GOVERNMENT OF THE DISTRICT OF COLUMBIA
DEPARTMENT OF TRANSPORTATION

MEMORANDUM

SUBJECT: BZA Case No. 19217 – 618 T Street NW

Figure 1 Site Access Plan (Source: Gorove/ Slade 608-618 T Street NW Traffic Statement)

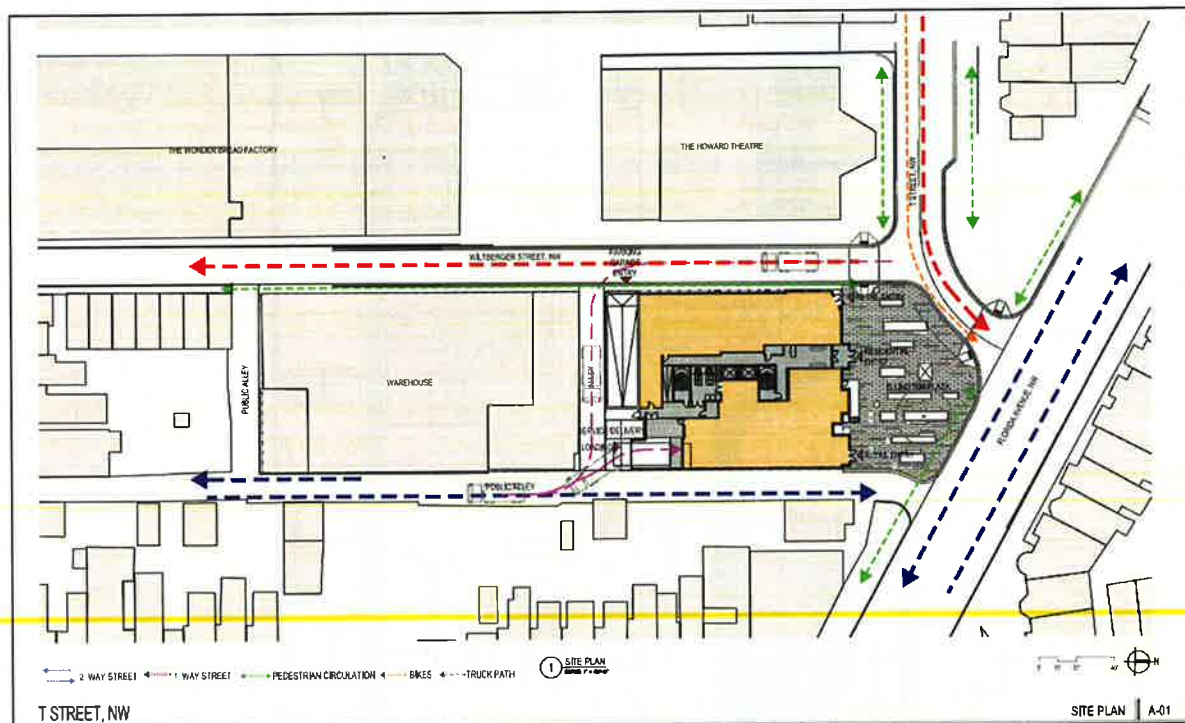
The site abuts Ellington Plaza to the north and Wiltberger Street to the west, with public alleys to south and east. Florida Avenue is the major street to the north of the site, adjacent to Ellington Plaza. The Applicant proposed primary pedestrian and bicycle access from Ellington Plaza. Vehicular access to the site is from Wiltberger Street or Florida Avenue. Wiltberger is a one-way street that can be accessed via the T Street/ 7th Street intersection. Access to below-grade parking is proposed via a curb cut from Wiltberger Street that has been approved by the Public Space Committee as shown.

All service vehicles including delivery and trash trucks are proposed to access the site via the public alley east of the site from Florida Avenue. Truck back-in maneuvers will occur within the public alley.

Figure 2: 30' Truck Maneuverability Diagram (Source: Gorove/ Slade 608-618 T Street NW Traffic Statement)

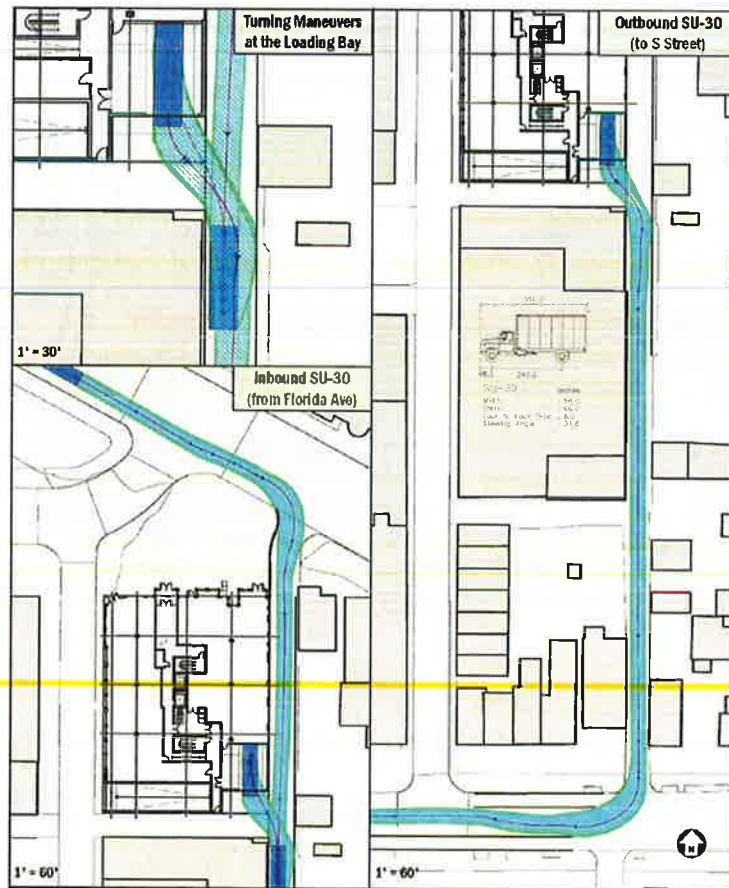
The Applicant is requesting relief from loading requirements; proposing to include one 30-foot loading berth and one 20-foot service/ delivery space in lieu of the required provisions for residential (one 55-foot loading berth and one 20-foot service/ delivery space) and retail (one 30-foot loading berth and one 20-foot service/delivery space). The loading and service/ delivery space is proposed to be located at the southeast corner of the site with direct access from the south and east public alleys. The Applicant's analysis includes truck turning diagrams showing that truck maneuvers can accommodate movements without backing into public space consistent with DDOT standards. DDOT finds a 30-foot loading berth and a 20-foot service/ delivery space are sufficient to accommodate loading demand and will have no adverse impacts on the travel conditions of the District's transportation network.

Considering that the Applicant is seeking a loading variance and due to congested alley conditions, DDOT will require the Applicant to submit a Loading Management Plan as part of the public space permitting process to minimize congestion and ensure efficient loading.

Figure 6: Pedestrian Infrastructure (Source: Gorove/ Slade 608-618 T Street NW Traffic Statement)

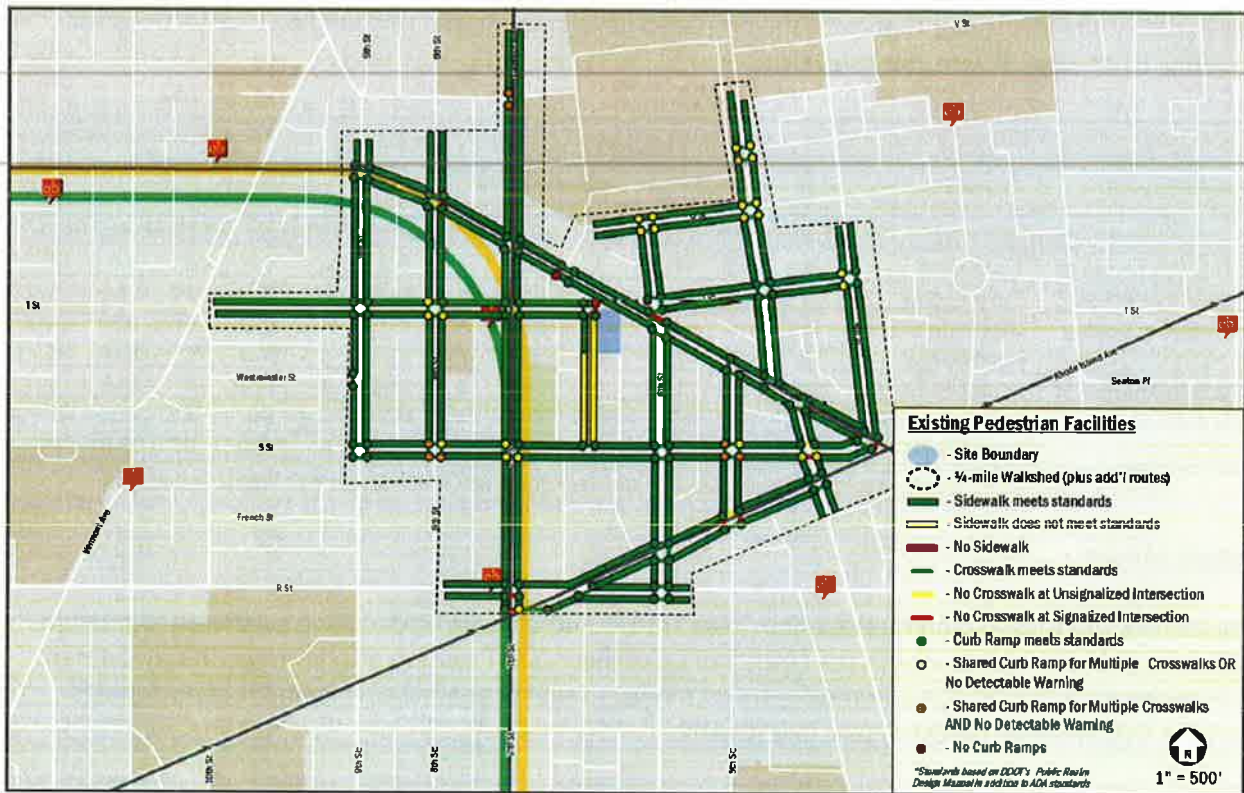
The Applicant performed an inventory of the pedestrian infrastructure within a quarter-mile of the site and noted that most of the pedestrian infrastructure is within acceptable conditions. The five-foot wide sidewalks along Wiltberger Street does not meet current DDOT Standards of 6-foot wide ; however, due to the narrow right-of-way and allocation of private space, the Applicant may leave the sidewalk in existing condition which meets ADA minimum clearance.
